**Staff Report**  
**Board of Architectural Review for Tru by Hilton**  
**Prepared July 16, 2018**

FILE NUMBERS: L18-0029 Design Review

REQUEST: Board of Architectural Review approval for a Tru by Hilton hotel of 92 rooms and related site improvements proposed at a vacant site on the northwest corner of Minkler Blvd. and Andover Park West.

**Figure 6.** TMC 18.28260.C. requires driveways in the TUC to be level with the height of the sidewalk.

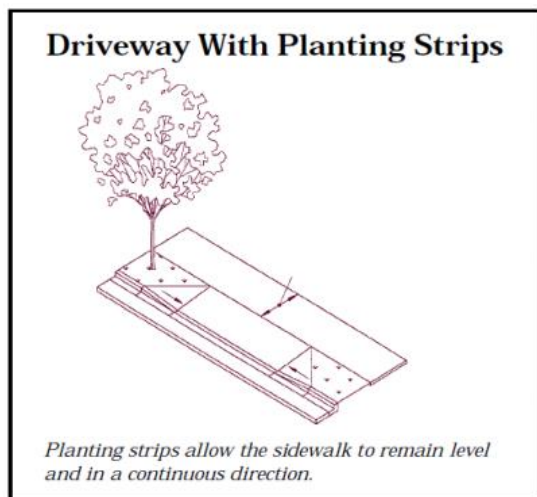
The sidewalk detail on the building permit will be reviewed for conformance with TMC 18.28.260.C.1.c, which requires the curb cut design for driveways to match the height of the sidewalk to ensure that the sidewalk stays at a consistent grade for pedestrians (see Figure 6).

3. At building permit submittal, provide cross-sections of the sidewalk grades along all frontages to be reviewed for ADA compliance and to ensure the grades of sidewalks stay at a consistent grade for pedestrians, even across driveway cuts.

**Figure 9.** Tru in Murfreesboro, Tennessee, showing a “top” with the rooflines.

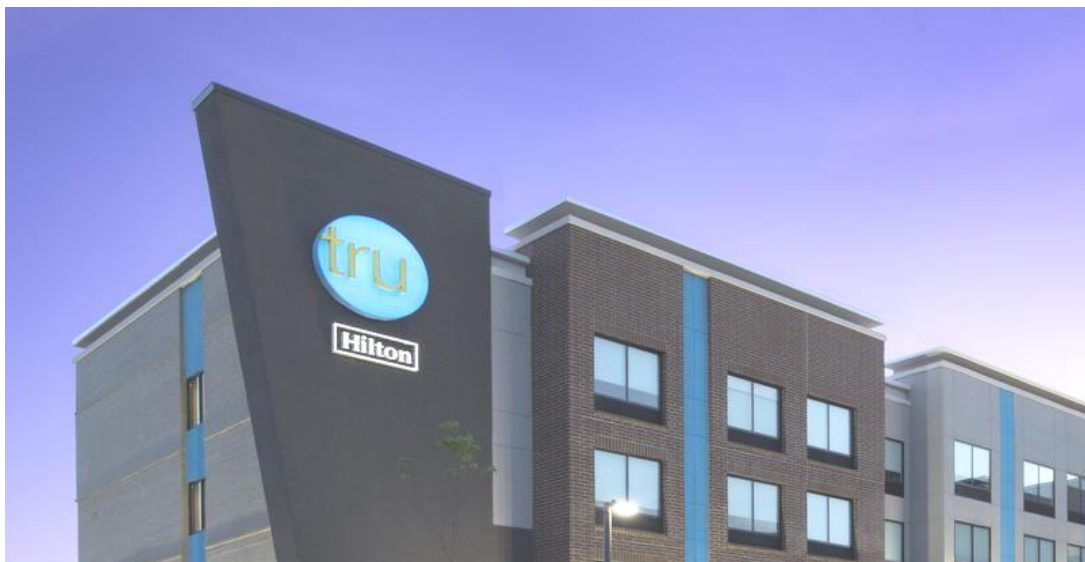
There are very slight variations in rooflines (2’ distinction in height) excepting the staircase projection for roof access, and only the southernmost portion of the eastern façade has a distinctive “top”. For the majority of the building, the roof is unarticulated by profile or color from the building’s exterior edge.

Potential design modifications that would increase the distinction of the roofline include:

- 1) Create a distinct roof line that includes details and cornice treatment similar to Figure 9.
- 2) Add a prominent cornice molding with distinct color similar to Figure 10.
- 3) Use different color, material and window pattern to treat the top story different that the remaining floors to create a distinct top similar to Figure 11.

- a. Create a distinct roof line that includes details and cornice treatment similar to Figure 9.
  - b. Add a prominent cornice molding with distinct color similar to Figure 10.
